**INSTRUMENT
APPROACH
CHART**

GWANGJU/Gwangju(RKJJ)
ILS/DME
RWY 04R

Change : Information of instrument approach procedure for RWY 04R.

GWANGJU/Gwangju(RKJJ)
PAR
RWY 22R

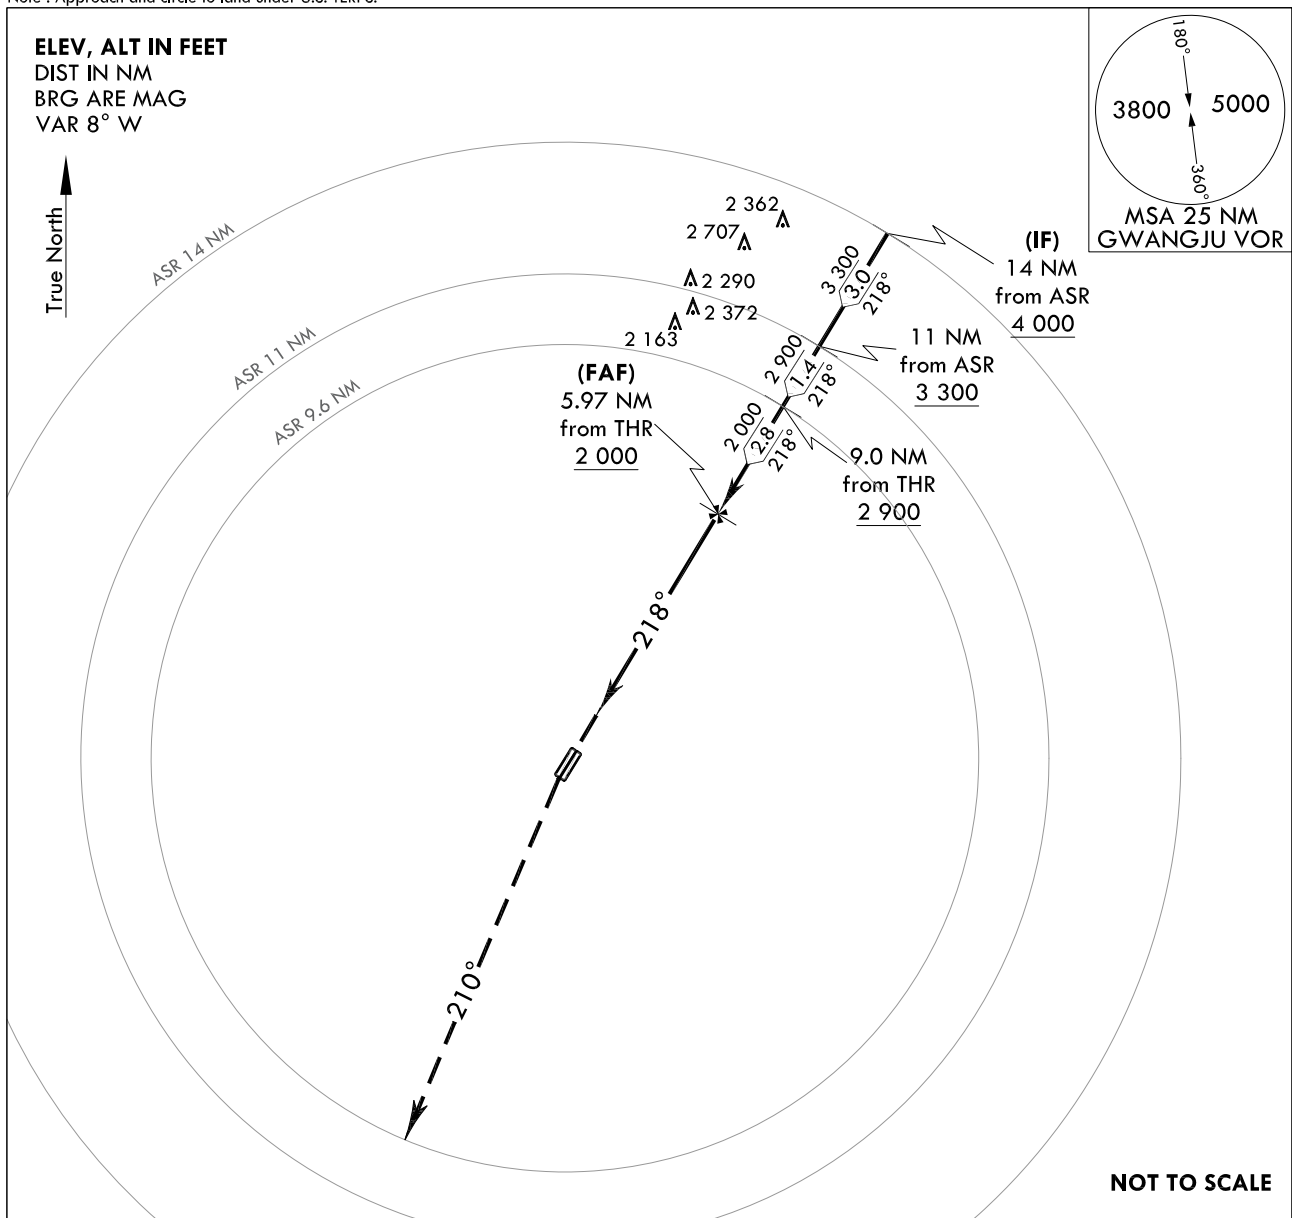
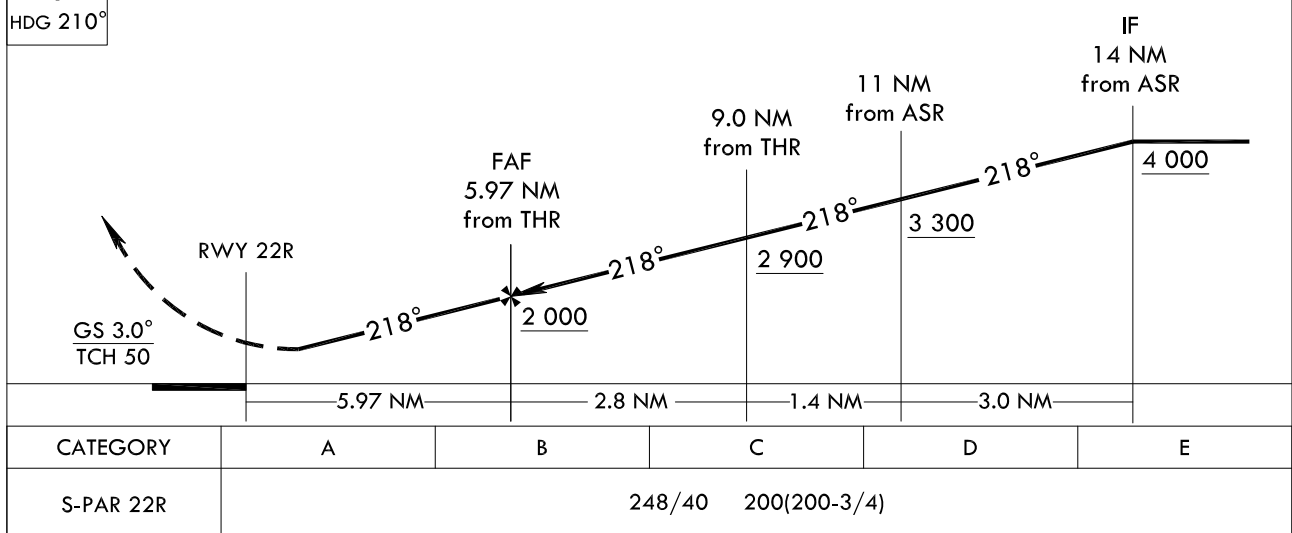
Change : Information of instrument approach procedure for RWY 22R.

GWANGJU/Gwangju(RKJJ)
ASR
RWY 22R

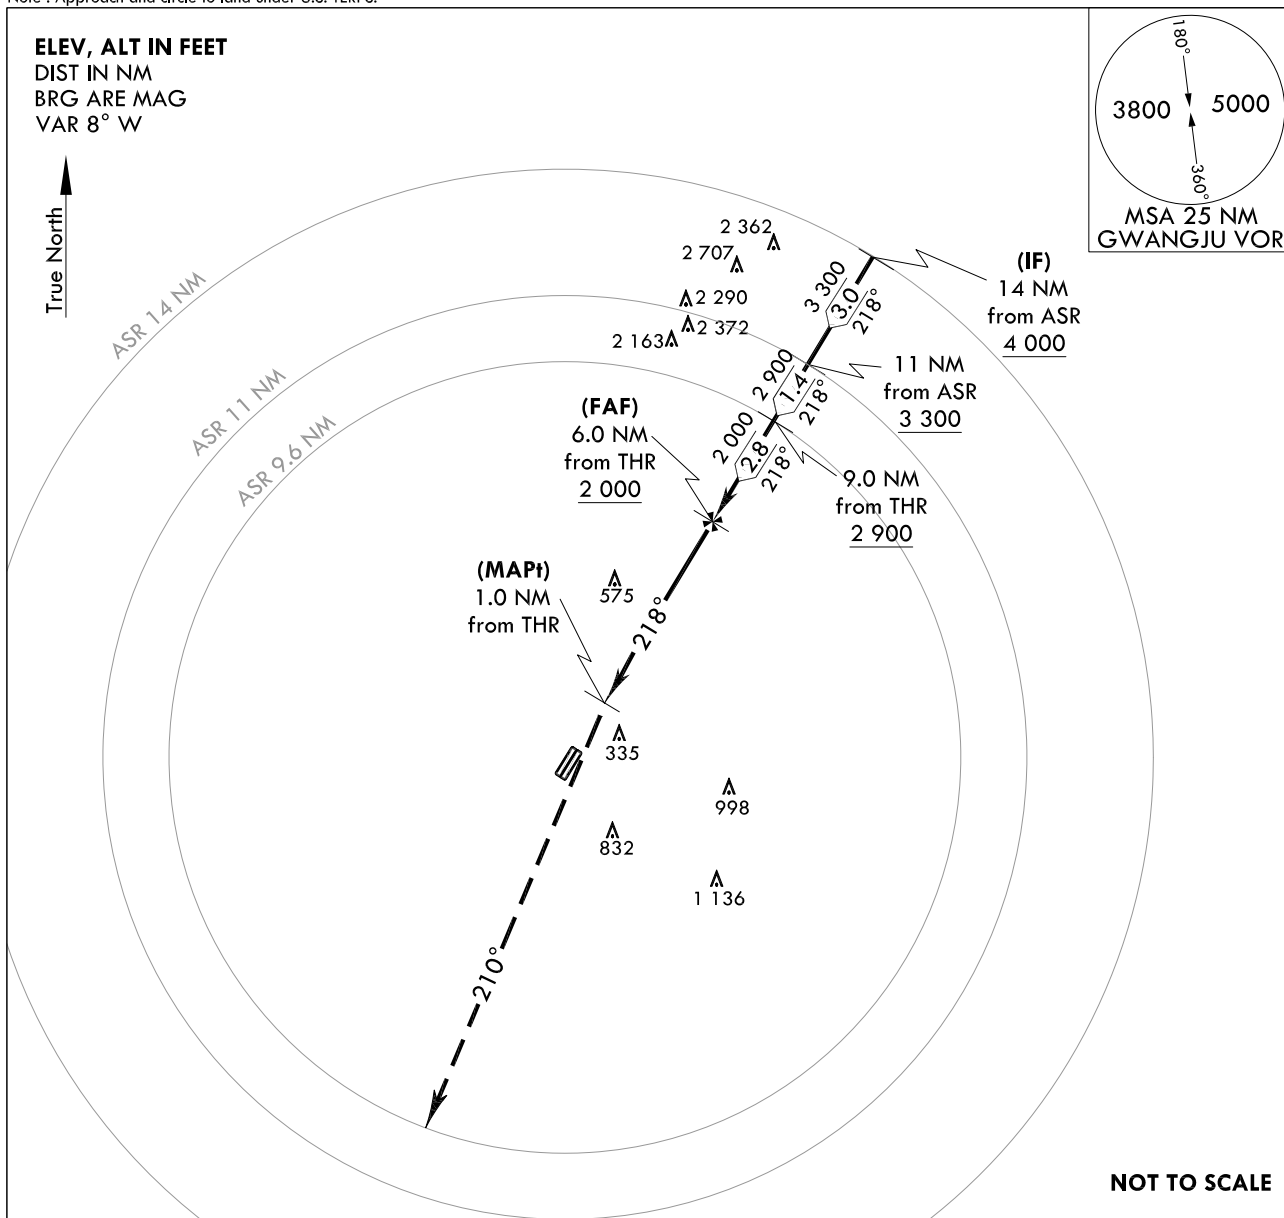
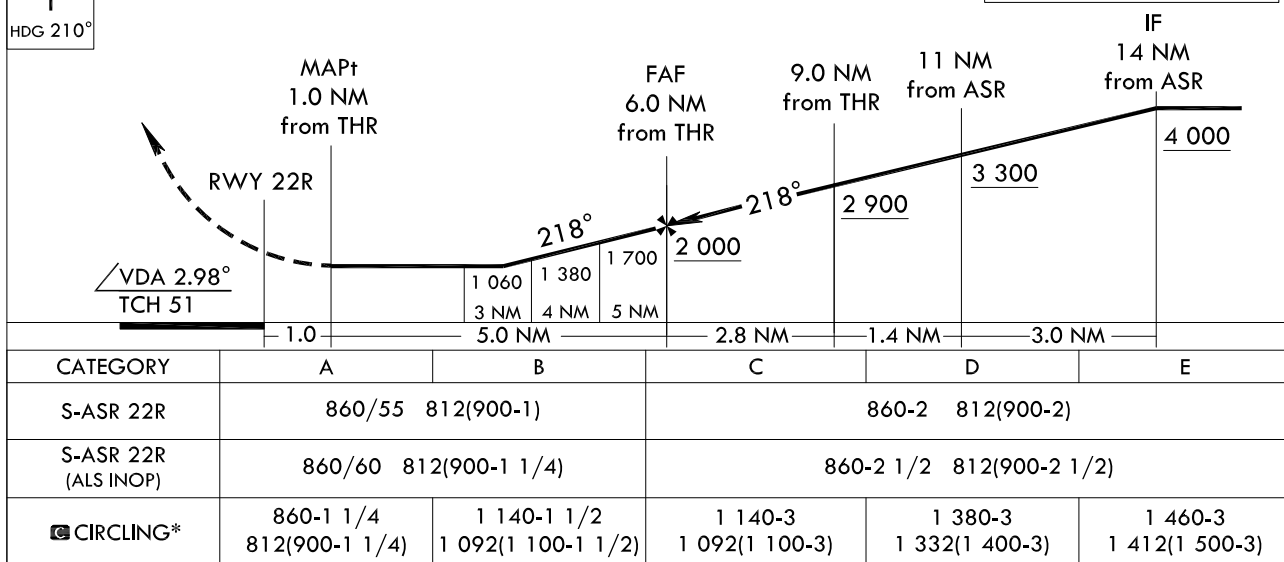
Change : Information of bearing($038^{\circ} \rightarrow 218^{\circ}$).
